T E C H N I C A L B U L L E T I N

#82 May 12, 1993

LUXFER TECHNICAL BULLETIN ENTITLED “COMPOSITE CYLINDER SAFETY NOTICE” (APRIL, 1993)

SUBJECT: COMPOSITE CYLINDER SAFETY NOTICE

Figure 1. Hoop Wrapped Cylinder Identification

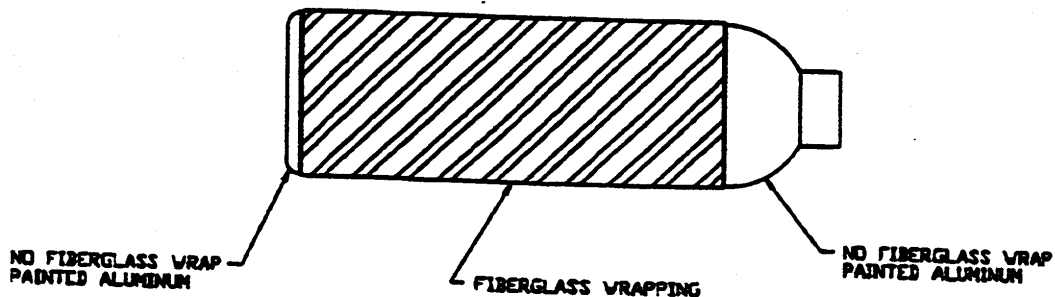
1. Examine only cylinders as shown in Figure 1.

Figure 2. Protective Steel Ring Location

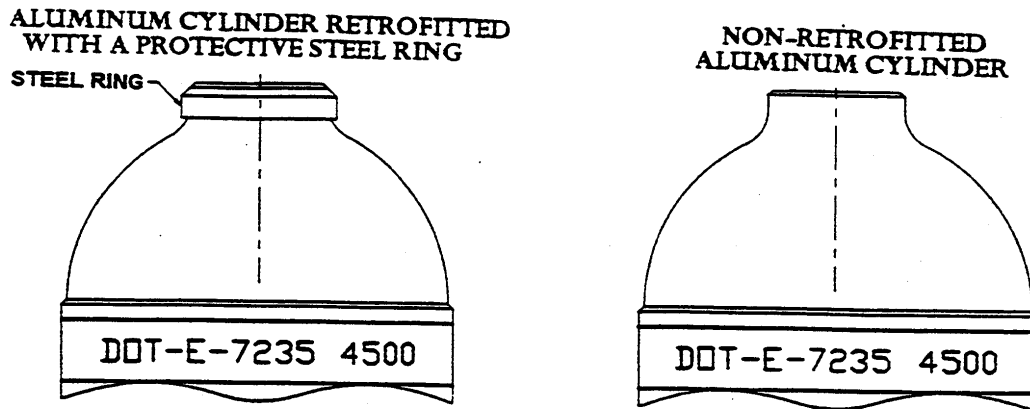
2. Examine the hoop wrapped cylinder for the protective steel ring on the cylinder neck as shown in Figure 2.

3. Protective steel rings may be difficult to identify on repainted cylinders. Apply a magnet to the neck area. A protective steel ring is present if the magnet sticks to the neck.
4. Cylinders without protective steel rings must be depressurized immediately. See paragraph 8 for depressurization instructions.

Do not use cylinders without protective steel rings. These cylinders could rupture at any time causing injury or death. Call Luxfer Customer Service immediately at (909) 684-5110 Monday through Friday from 8:00 AM to 4:30 PM Pacific time. Luxfer will arrange to retrofit cylinders free of charge.

Figure 3. Hydrostatic Test Date Location
Cylinder Crown (top view)

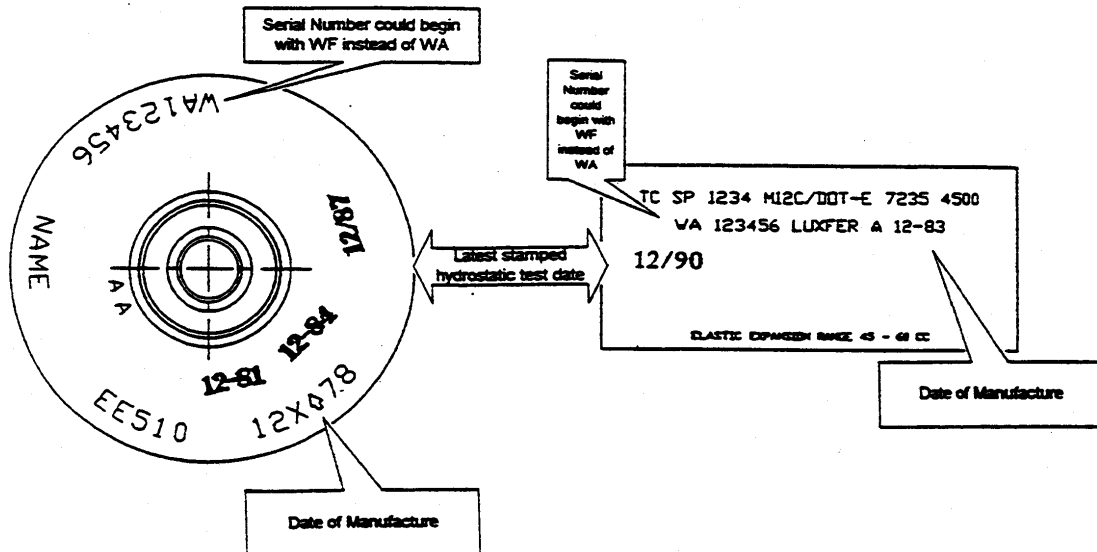
5. Cylinders with protective steel rings can be returned to service if:
- No more than three years have elapsed since the latest stamped hydrostatic test date. Hoop wrapped cylinders may have the retest markings stamped on the top head of the cylinder or placed on a label securely affixed to the cylinder and overcoated with epoxy. See Figures 3 and 4.
 - No more than 15 years have elapsed since the date of manufacture. See Figures 3 and 4.

6. If the last hydrostatic test date is older than three years, depressurize the cylinder and have it hydrostatically tested. See paragraph 8 for depressurization instructions.
7. If the manufacturing date is older than 15 years, depressurize the cylinder and then destroy it by drilling at least one hole (minimum 1/4" diameter) in the cylinder side wall. See paragraph 8 for depressurization instructions.
8. Depressurize your cylinders by doing the following:
 - a. Secure the cylinder in a holding device or place in a restraining fixture to keep cylinder from moving about, slowly turn valve handwheel to slowly release cylinder contents.
 - b. Protect the sidewall of the cylinder from damage to the fiberglass wrap by covering a chain gripping device with cloth or rubber material.
